REFERENCE:	Nova Bus Manuals
SECTION:	16: Electrical System
RS N°:	MQR 7621-813
EFFECTIVE IN PROD.:	L859 (2014DE)

SUBJECT:	Battery cables
JUSTIFICATION:	Terminal lugs of the battery cables may crack due to stress.

Figure 5 - Removal of Existing Battery Cables

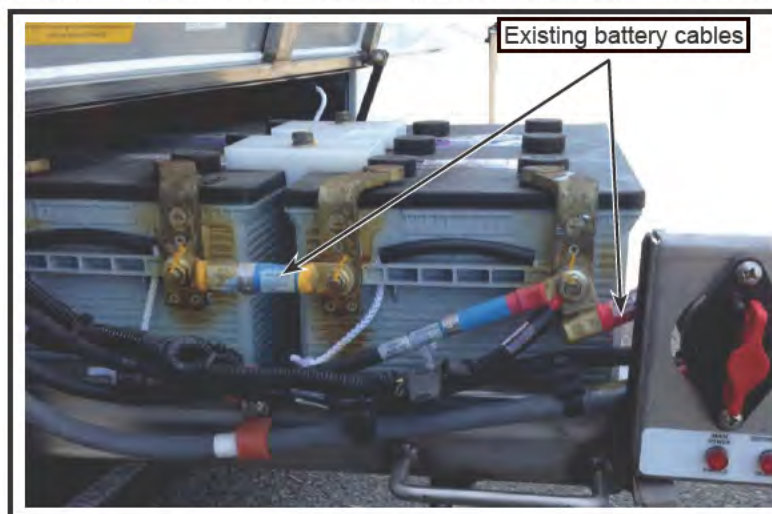
- 1.5. Remove the existing battery cables as shown in Figure 5. Retain the nuts. Discard the cables.

Figure 6 - Installation of New Battery Cable (N82782-01)

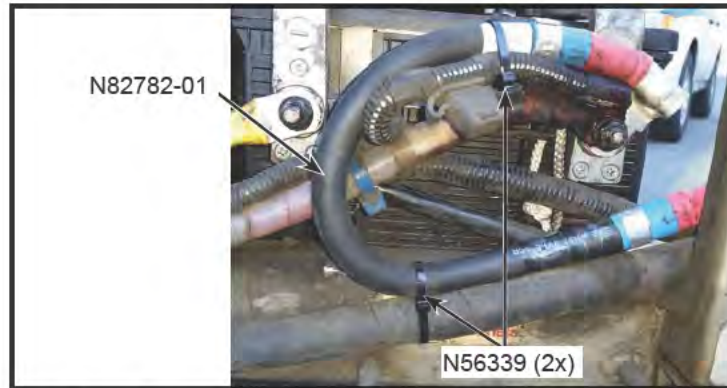
- 1.6. Install N82782-01 battery cable between the battery disconnect switch and the battery. Do not tighten the nuts (see Figure 6).
- 1.7. Install 2x N56339 cable tie to support the battery cable (see Figure 6).

Figure 7 - Torque Values for Battery Connections

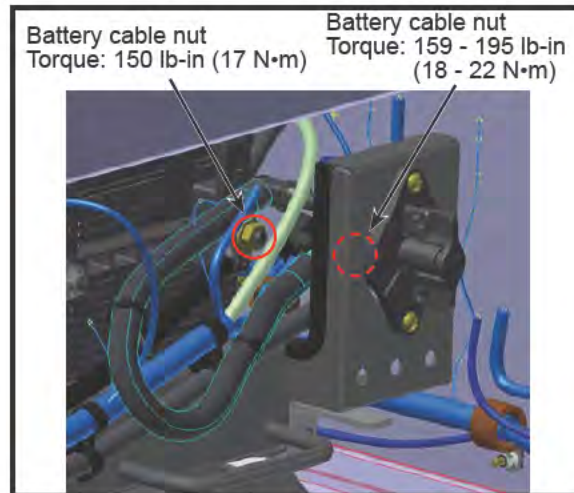
- 1.8. Tighten the battery cable nuts. See Figure 7 for torque specifications.

Figure 8 - Installation of New Battery Cable (N82783-01)

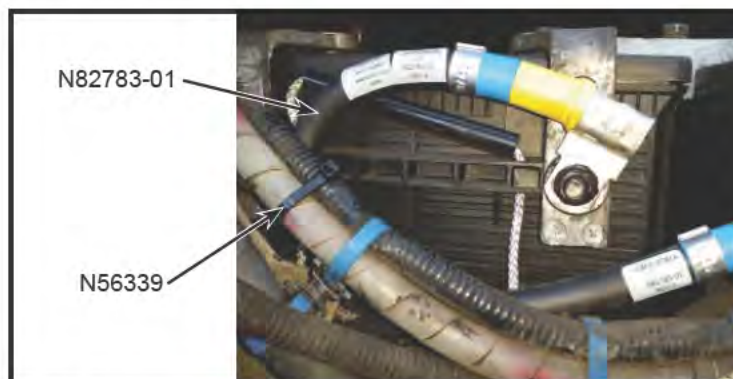
- 1.9. Install N82783-01 battery cable between the batteries. Install N56339 cable ties to support the battery cable. Do not tighten the nuts (see Figure 8).
